Technical Note

To	John Carr (ARTC)	From	Trinity Graham (FFJV)
Copy	Ben Lippett (ARTC)	Reference	2-0001-270-IHY-10-TN-0012_Rev 0
Date	10 December 2021	Pages (including this page)	28
Subject	Response to DPIE RFI regarding further modelling and assessment of velocities through culverts

Figure 1 Afflux Map for Mitigated Reference Design (SM1) – 1% AEP event with climate change

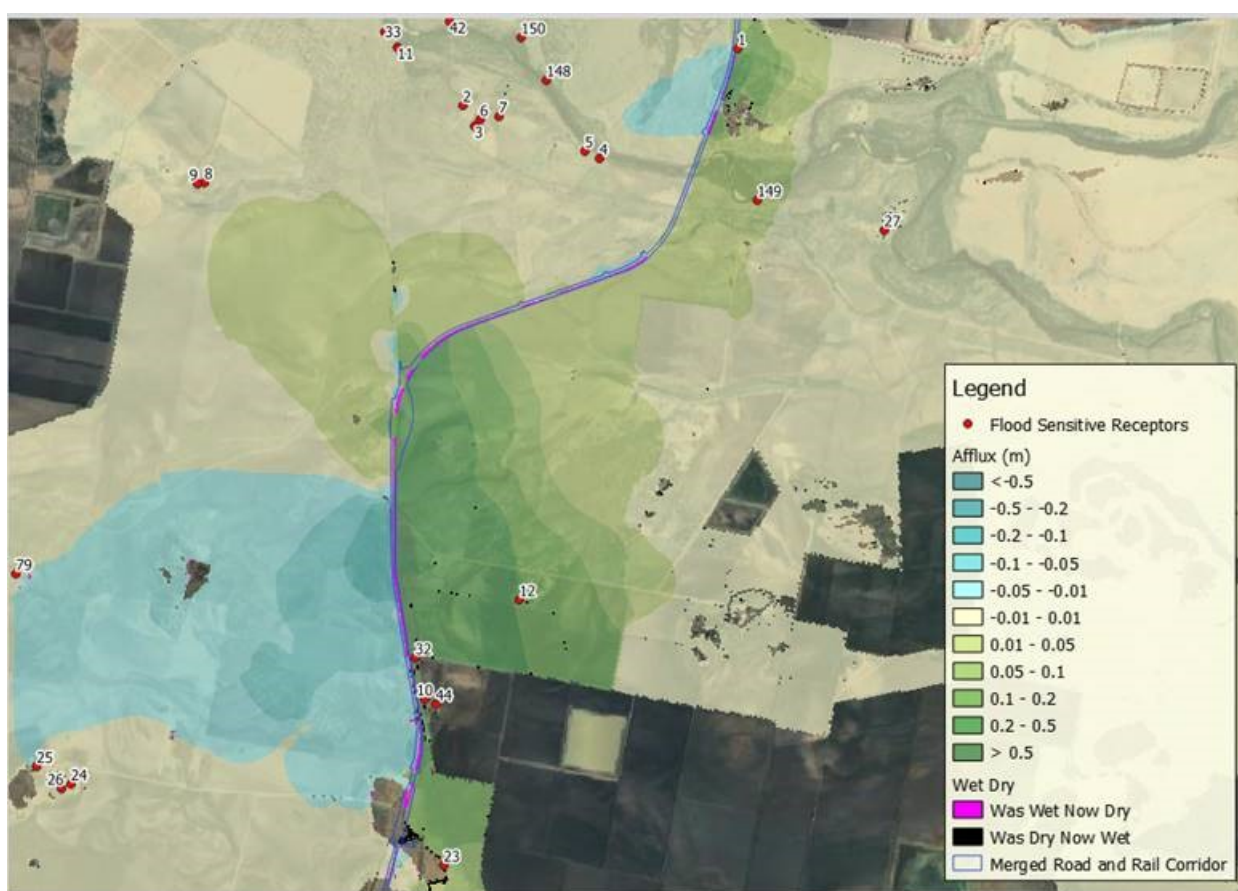
- *The EIS indicated that the rail line would not be overtopped. Please advise whether this remains the case with the revised modelling in the PIR and provide details of any overtopping of the rail alignment and / or additional impacts to residences and infrastructure.*

Review of the 1% AEP climate change event modelling results confirms that overtopping of the alignment does not occur under this event. Whilst the peak water levels from the 1% AEP event with climate change are slightly higher upstream of the alignment than the 1976 flow scenario (approximately 30 to 100mm), similar afflux outcomes are predicted.

Figure 3 Flow comparison across floodplain – 1976 flow scenarios

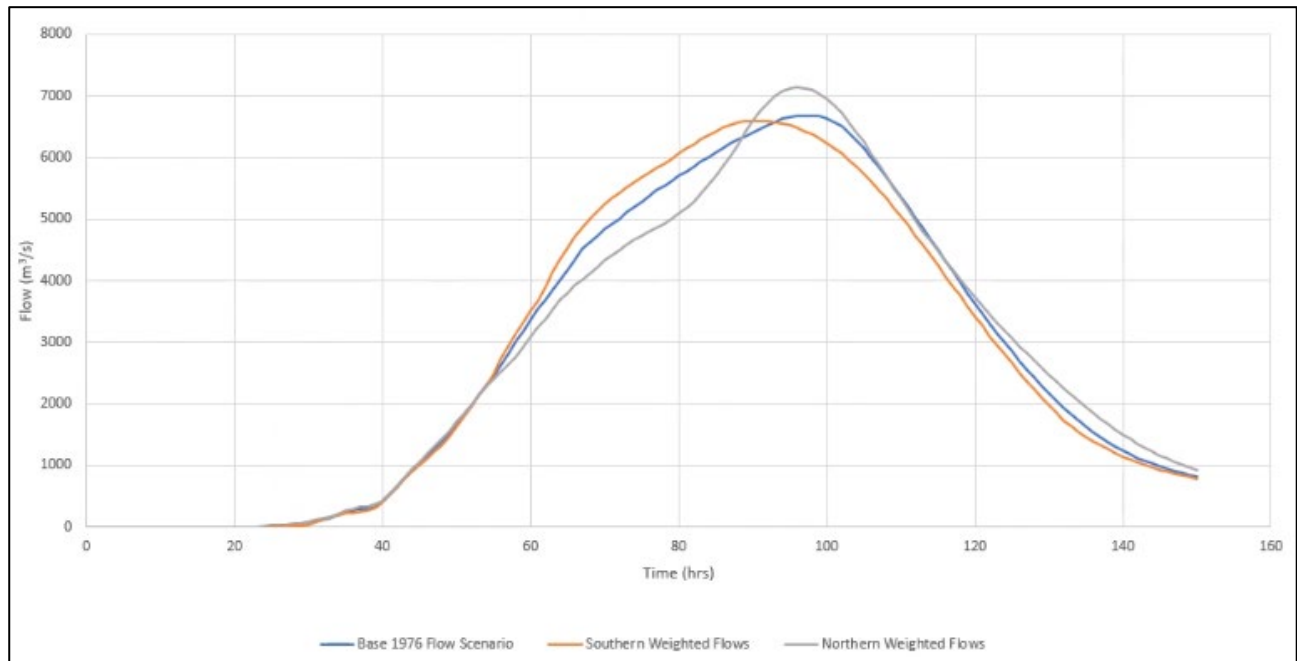
- *There is a large section of the alignment with little cross drainage where the PIR models flows running parallel to the rail alignment. With different spatial distributions of rainfall in the upstream catchments, the proportion of flows arriving on each side of the alignment may alter necessitating provision of additional cross drainage to equalise conditions on each side of the alignment.*
- *Please examine the spatial variation in historical rainfalls and use this to determine alternative flow distributions for the design floods. These should then be used to examine the adequacy of the*

currently proposed cross drainage infrastructure and where necessary, provide additional cross drainage infrastructure to ensure the QDLs are satisfied under alternative flow distributions.

Figure 3 presents the flow across the width of floodplain near the junction of the rivers for both of the weighted scenarios and the base 1976 flow scenario. This figure shows that similar peak flows and overall flood volumes are achieved across these three scenarios.

Figure 8 North Star camp modelling results

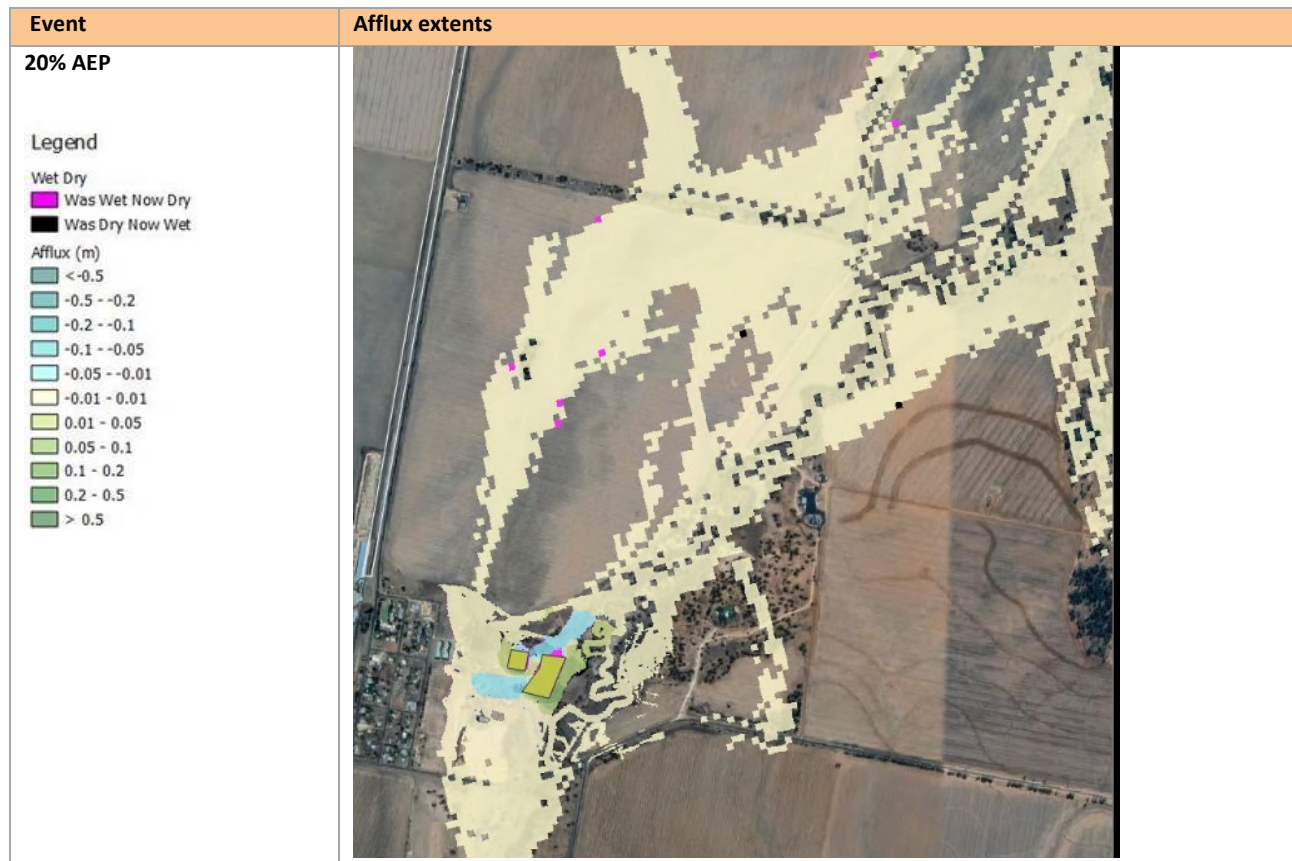
In addition, results from modelling carried out in relation to the North Star construction camp are provided in Section 5

The model results in Figure 8 demonstrate compliance against the draft QDLs. The camp layout is indicative but is within the footprint included in the Project Description. The hydraulic model includes an at-grade channel between the two parts of the camp which is provided as a mitigation measure to meet the proposed QDLs. A bund would be included around the perimeter of the camp to provide flood immunity. This design would be further developed and finalised during the detailed design phase.
